CONSERVATION COMMISSION AGENDA

The Conservation Commission will hold this meeting as a virtual meeting on Thursday, February 18, 2021 at 7:00 pm. No in-person meeting will take place at City Hall.

1. 145 Warren Street – cont'd NOI – renovation and additional units onto single-family home – DEP File #239-882

2. 25 Bernard Street – NOI – teardown and rebuild single-family home – DEP File #239-883

GRADING, DRAINAGE & UTILITY PLAN
NEWTON, MASSACHUSETTS
SHOWING PROPOSED CONDITIONS AT
#145 WARREN STREET

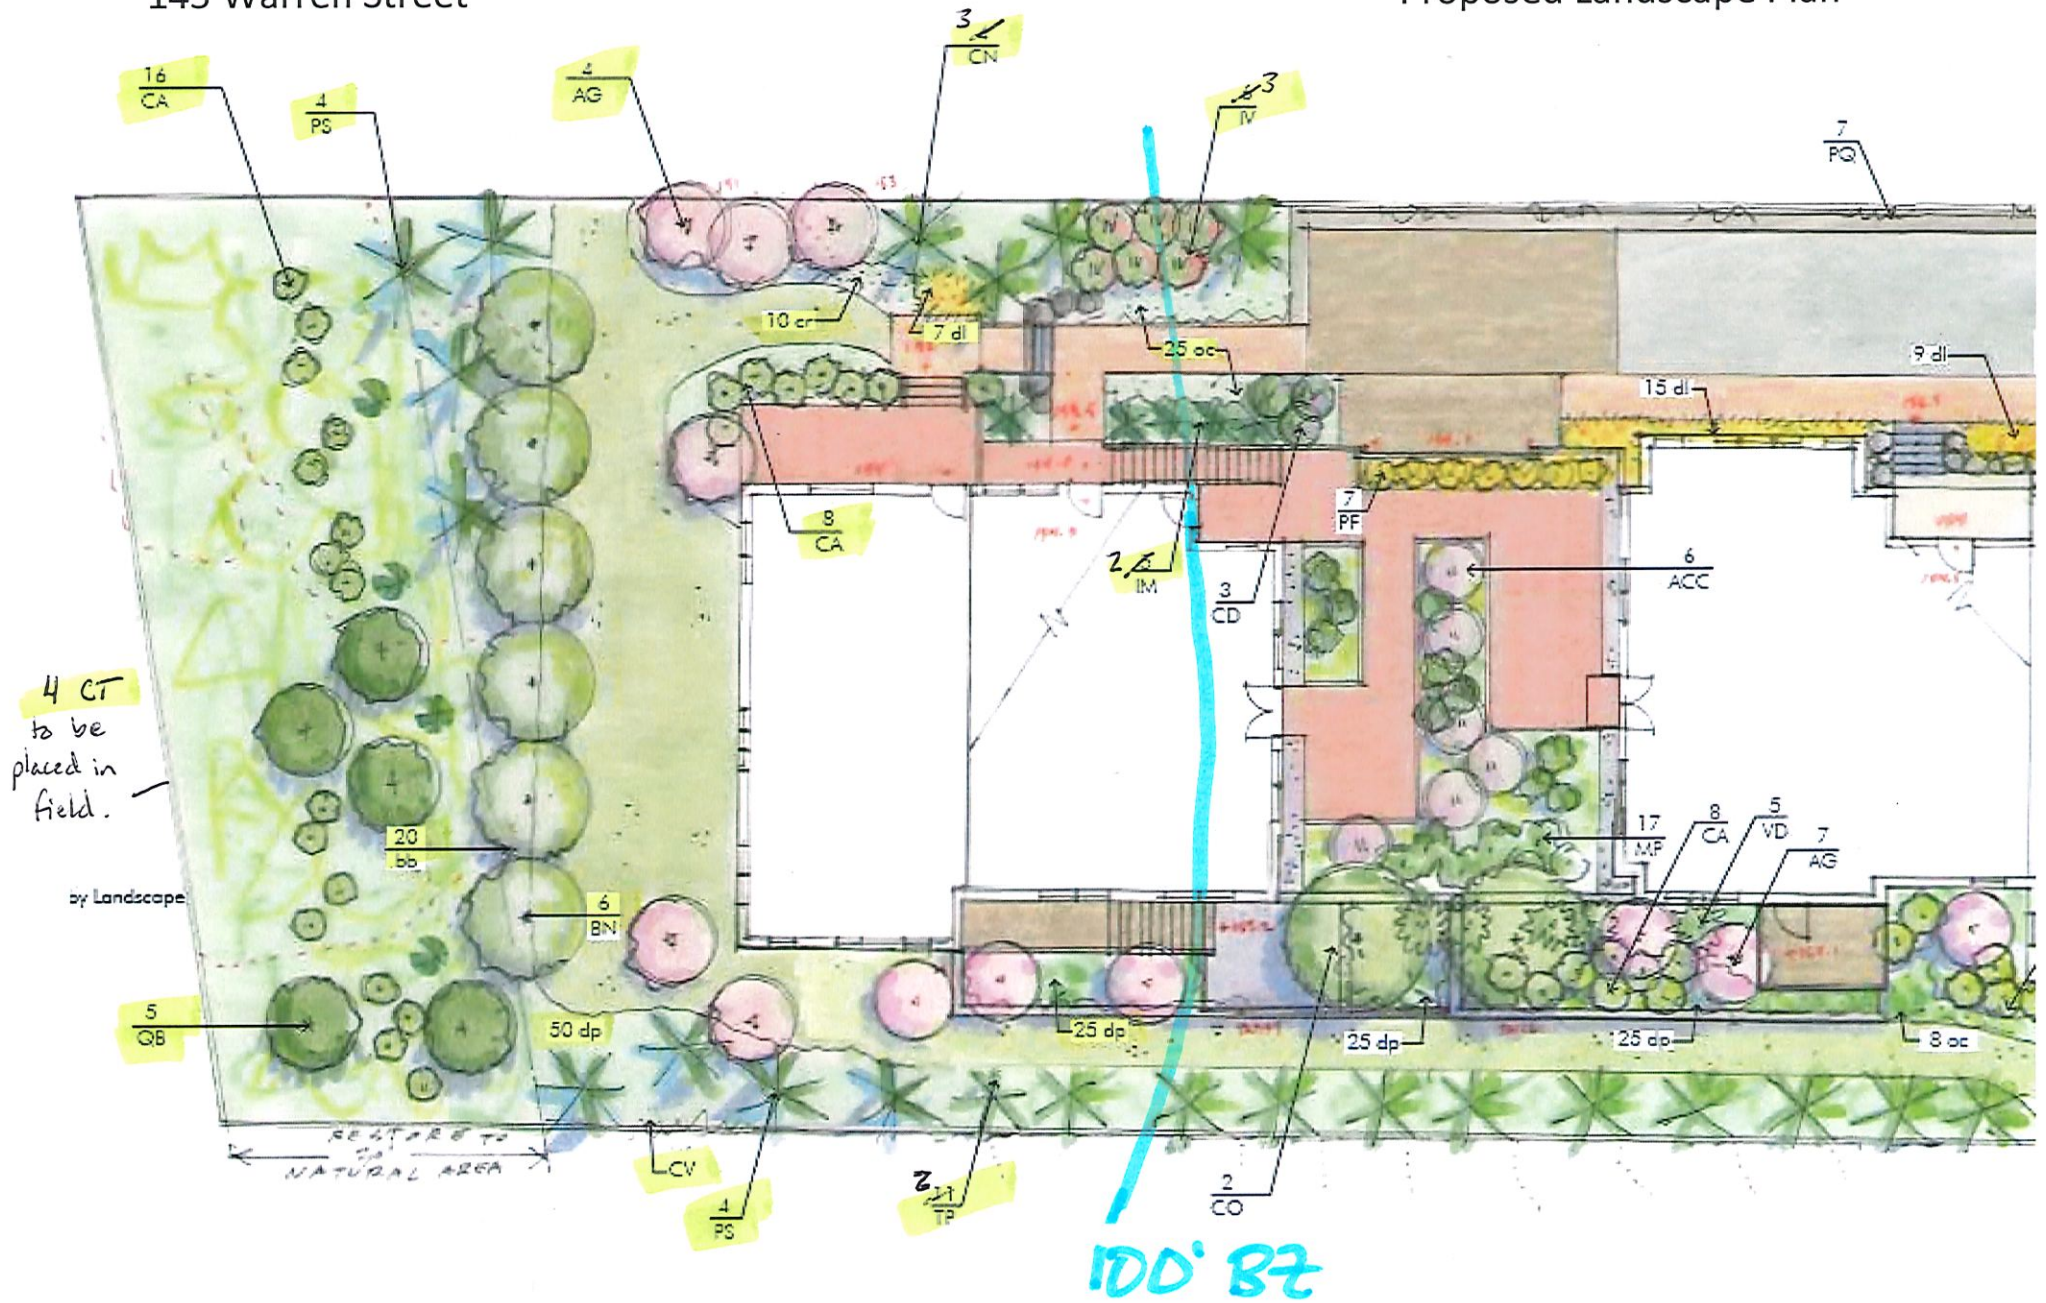
- The site is extremely tight. A preliminary phasing plan must be submitted that clearly illustrates that there is/will be appropriate access for all excavation, construction (e.g., construction of the retaining wall on the western property line), stockpiling, dewatering, access for planting, etc.

- Because the site is so tight, erosion controls should be silt fence reinforced with wire fence.
- Infiltration areas will likely be subject to significant compaction during demolition and construction. Engineering should require proof of percolation rates immediately prior to installation.

- Significant tree plantings are proposed right next to the infiltration chambers. The applicant should clarify how that might affect long-term performance (and maintenance) of the chambers.

- A revised stormwater report must be submitted.
 - Recharge Systems
 - System No. 1 conforms to the Engineering Division stormwater policy
 - System No. 2 must have test pit dug within 25-feet of this system

- System No. 3 must have SHGWT confirmed, must be reassessed with the correct exfiltration rate, must be provided with adequate coverage
 - System No. 4 must be provided with adequate coverage, must have the overflow pipe raised

- The flared end overflow should have a stone rip rap swale to prevent erosion. Note: It is possible that when the overflow invert elevation is adjusted, the overflow may not be required.

- A dewatering plan must be submitted. A site stockpile area needs to be identified on the plans.
- **Staff Recommendations:** Address the questions and concerns above and others raised during the hearing, then, if/as appropriate, vote to close the hearing and issue an Order of Conditions with the following special conditions.

- Engineering requirements
 - A revised stormwater report must be submitted.
 - Recharge system no. 2 must have test pit dug within 25-feet of this system.

- Recharge system no. 3 must have SHGWT confirmed, must be reassessed with the correct exfiltration rate, must be provided with adequate coverage.
 - Recharge system no. 4 must be provided with adequate coverage, must have the overflow pipe raised

- A dewatering plan must be submitted.
 - A site stockpile area needs to be identified on the plans.
 - The flared end overflow (if it is installed) must have a stone rip rap swale to prevent erosion.

- Stone bounds (3' granite posts) must be installed (2.5 feet deep with a 6" reveal) at the edge of the marked lawn line on the eastern property boundary and in the corner of the lawn line near the western property line to foster long-term maintenance of the planting area.

25 BERNARD ST - PROPOSED CONDITIONS

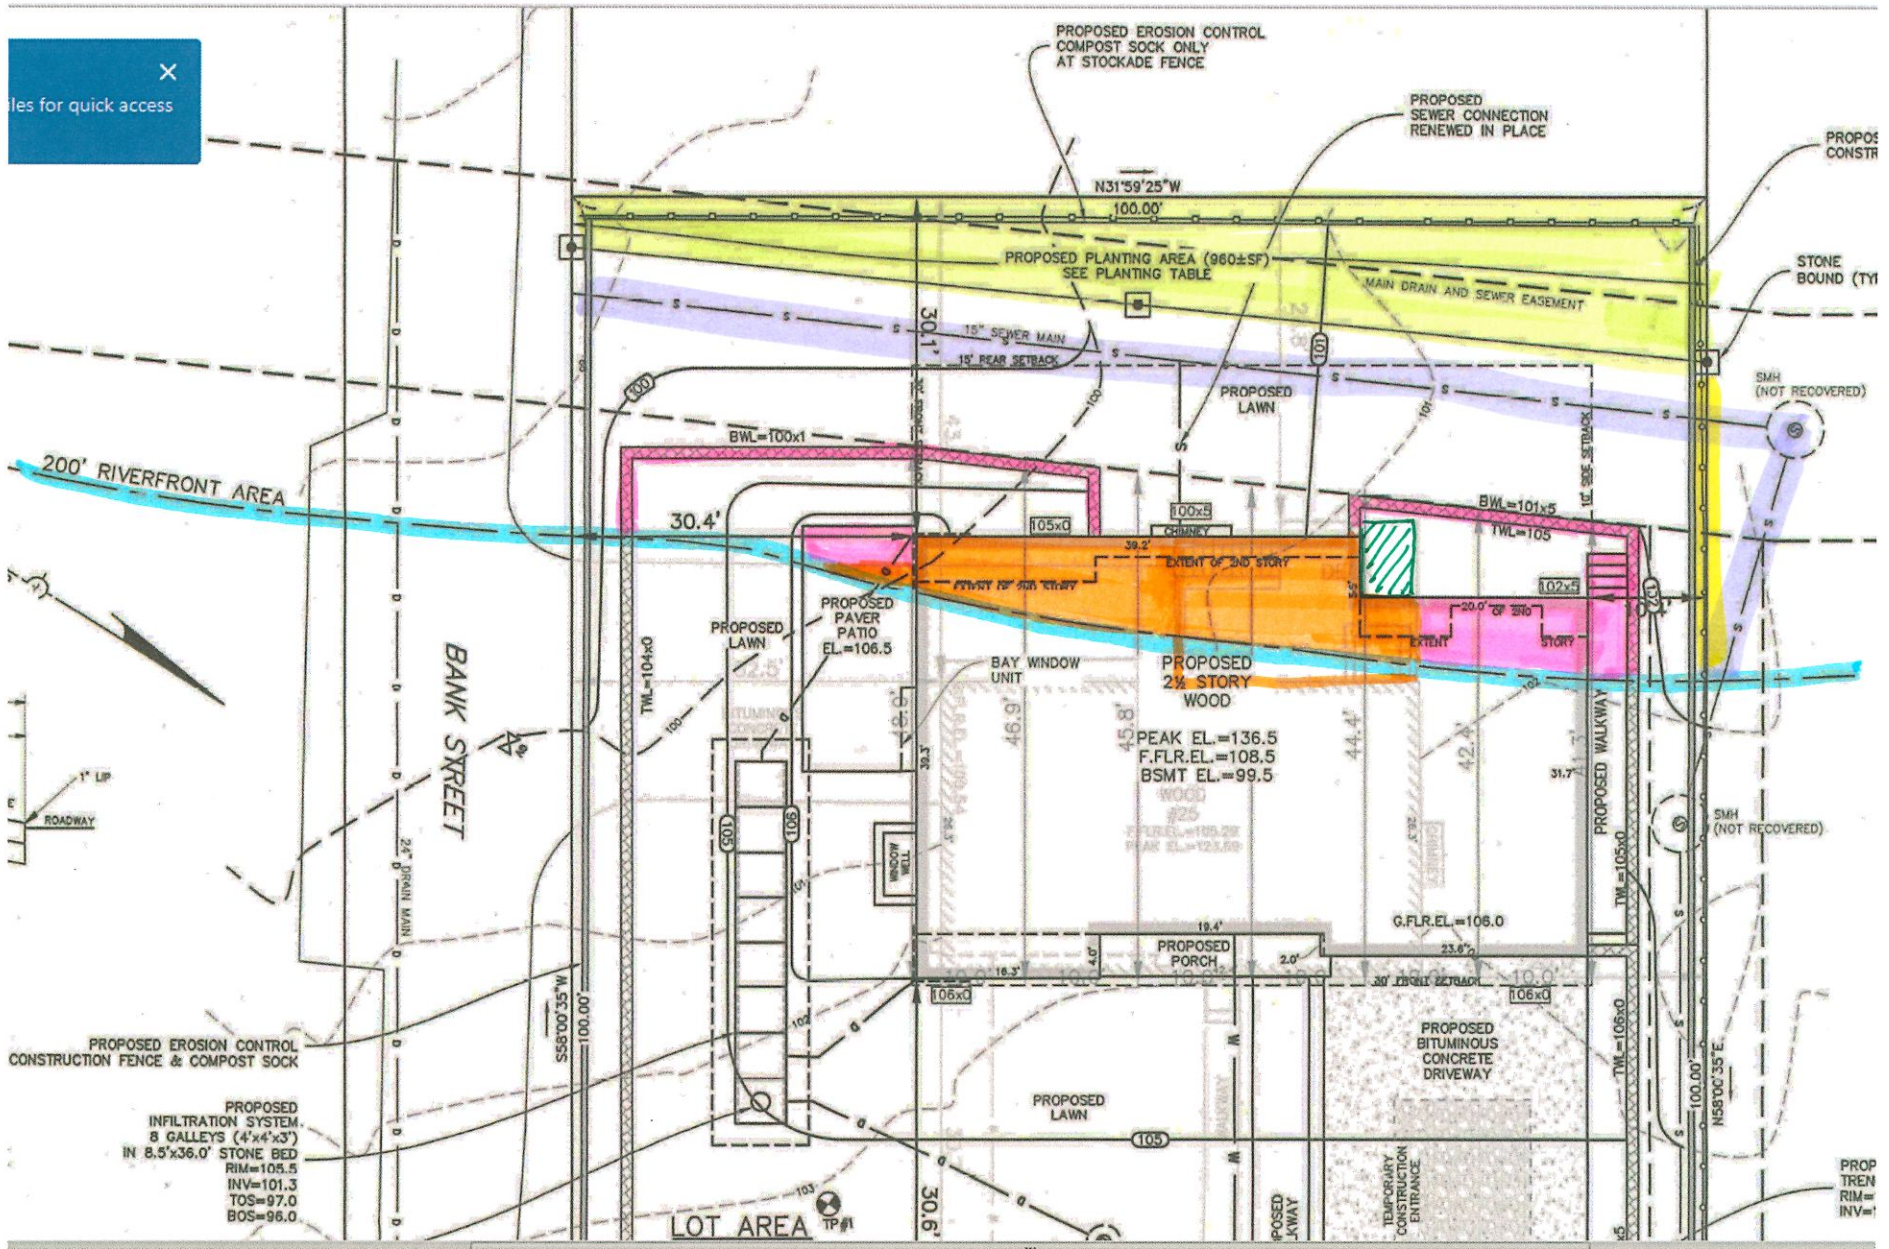
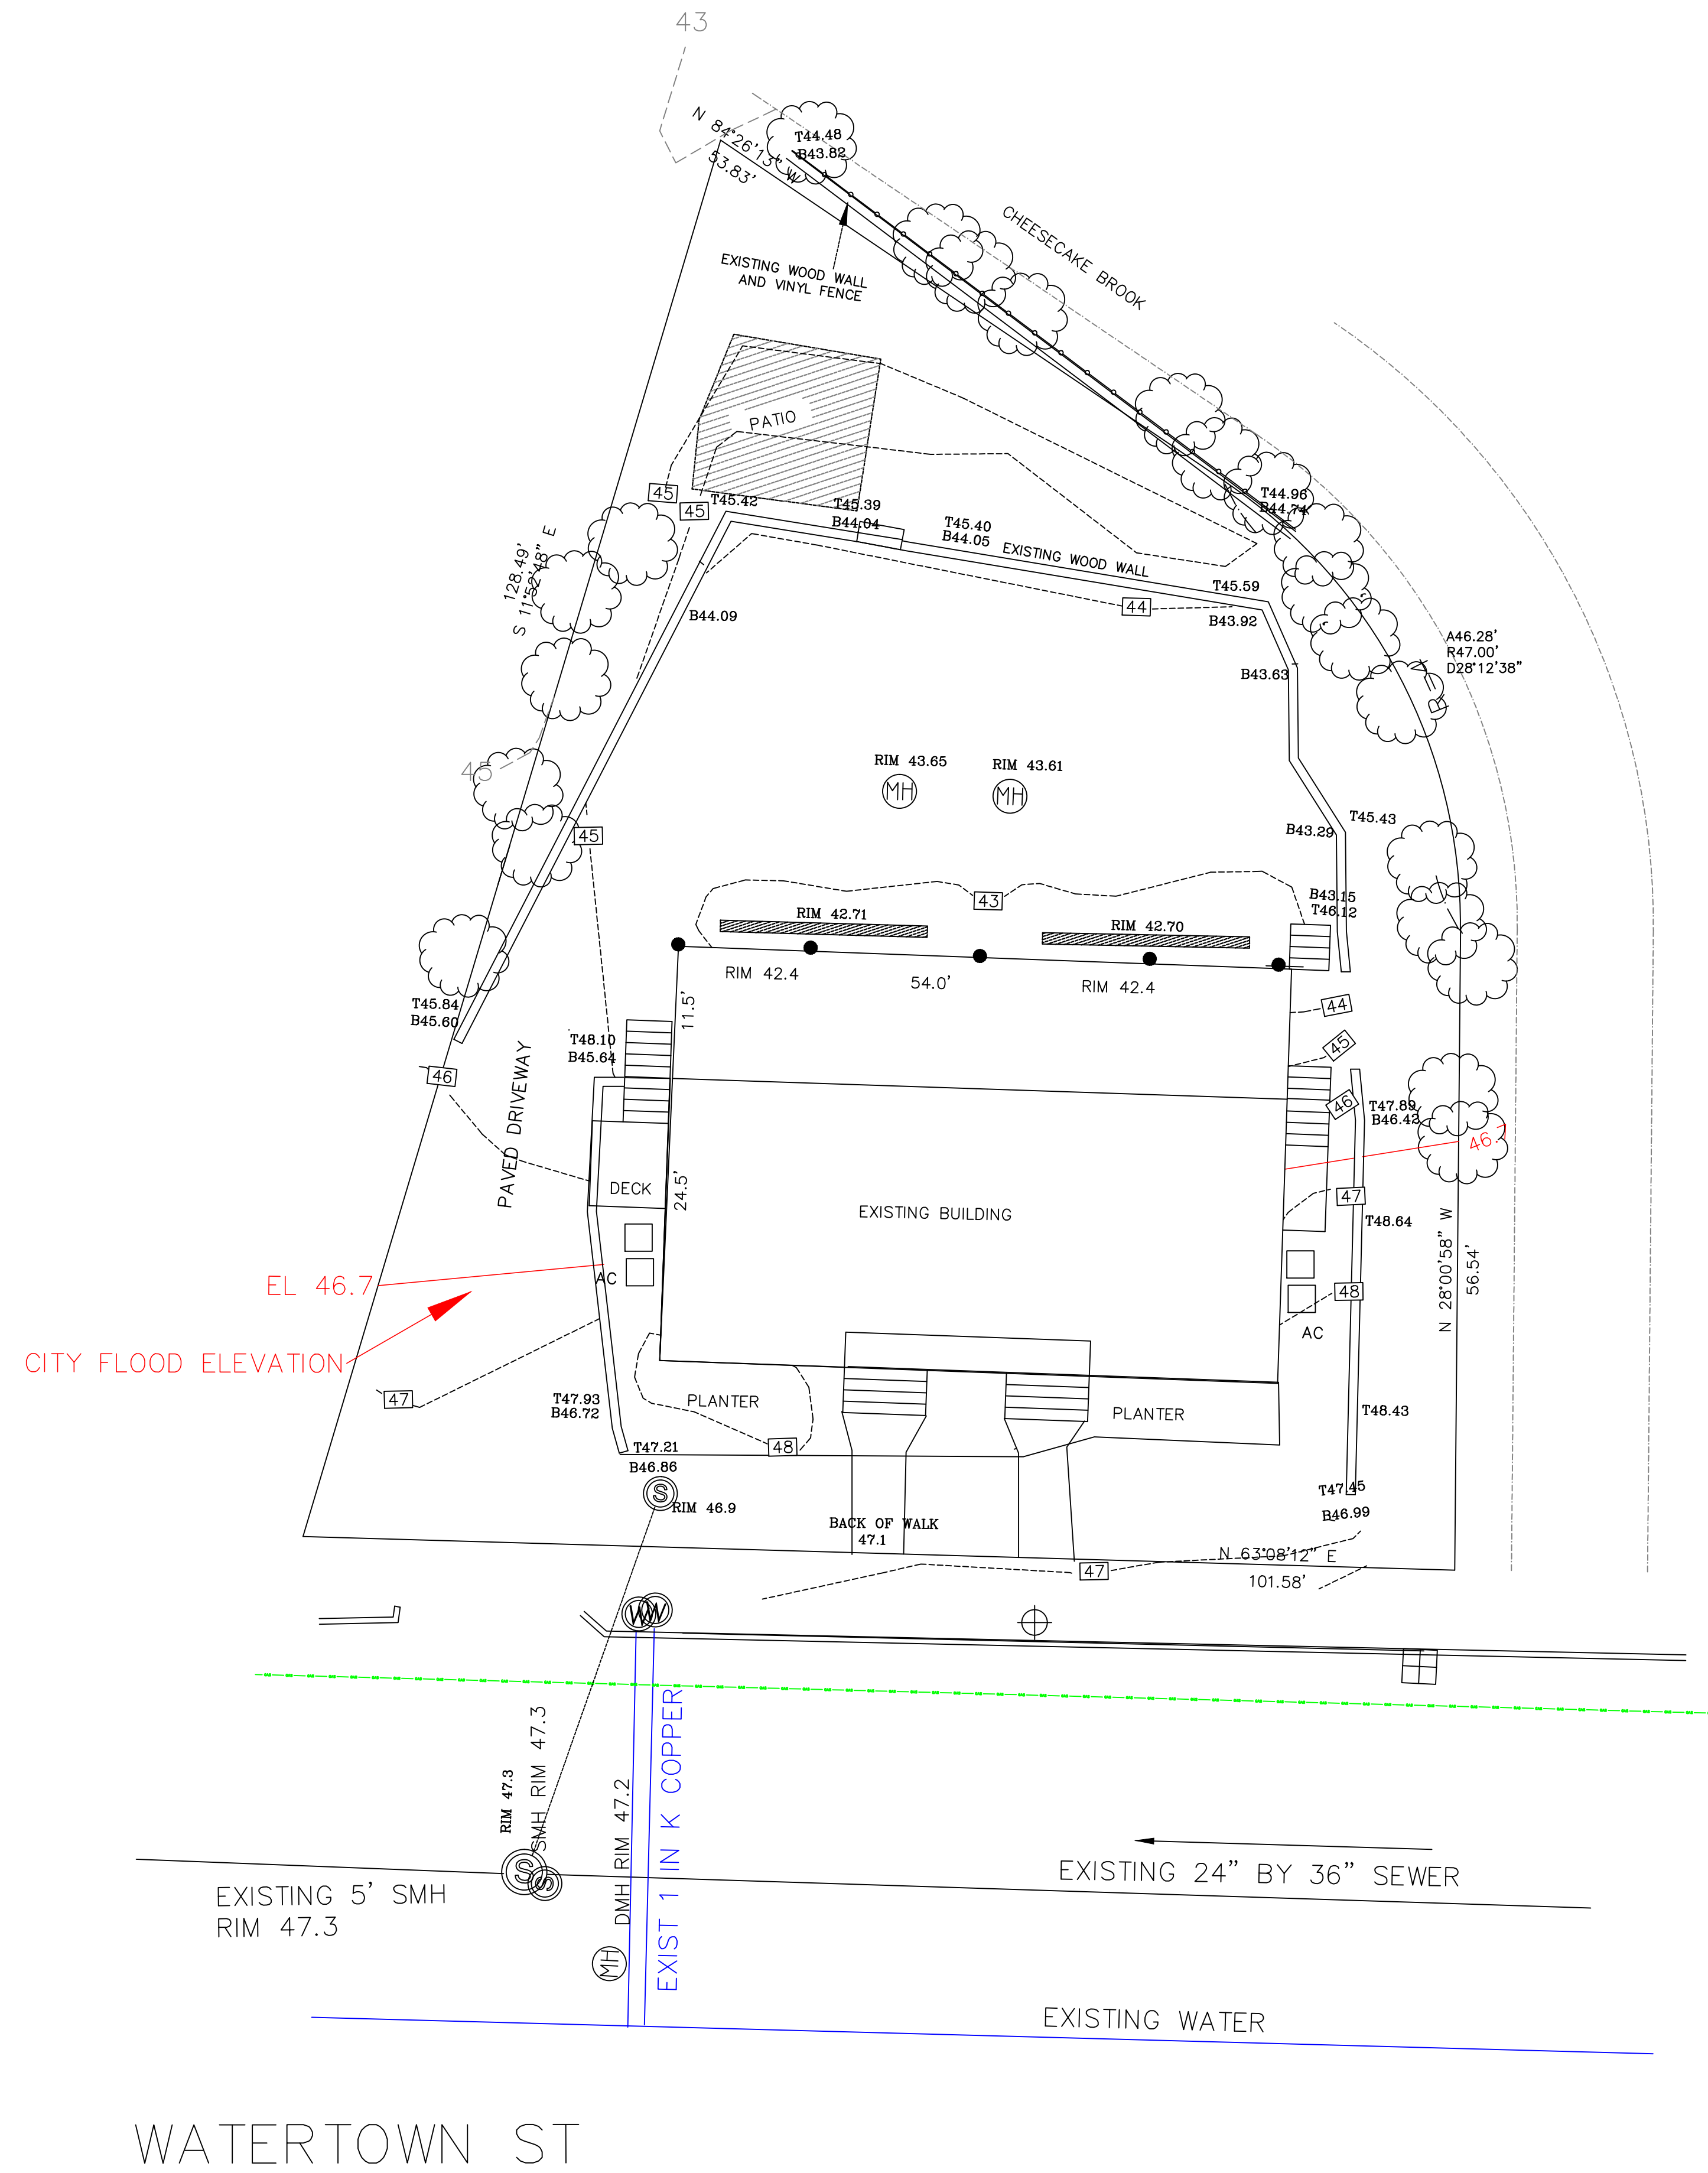
- Currently, there is no access shown from the rear of the house to the rear lawn area. Staff imagine that a deck and/or stairs may be desired. Although such structures may be considered exempt, they should be shown on the plan and accounted for in the proposed degraded area within RFA (and the mitigation planting area).

- The proposed planting area is in the drain and sewer easement, so no canopy trees can be planted. The proposed planting schedule seems appropriate. Staff have concerns about 6" elevated stone bounds within the drain and sewer easement and the danger they may pose to maintenance vehicles travelling through the easement; staff suggest elevating the stone bounds 2".

- The applicant should clarify whether pre- and post-construction monitoring of the sewer line will be required by the Engineering Division.
 - The proposed retaining walls will restrict wildlife movement, but a very limited amount of Riverfront Area will be affected by the impingement and the wildlife habitat value of the up-gradient area is limited.

- Staff note a typo in note #13 (stamPed).
- Staff Recommendation: Address the questions and concerns above and others raised during the hearing, then, if/as appropriate, vote to close the hearing and issue Newton's standard Order of Conditions with the following special conditions.

- Landscape plantings within Commission jurisdiction must:
 - a. Stabilize all exposed areas.
 - b. Be installed in compliance with the approved plans (desired changes must be approved by the Conservation office in advance).

- c. Have a survival rate of XX % of total number of shrubs (after 2 growing seasons).
 - d. Mulch use shall decrease and eventually cease as plant material spreads throughout the enhancement area.

- The stormwater infiltration system must be installed as per the approved plans.
 - The City Engineer must inspect the infiltration system. The applicant must submit proof of inspection to the Cons. Office.
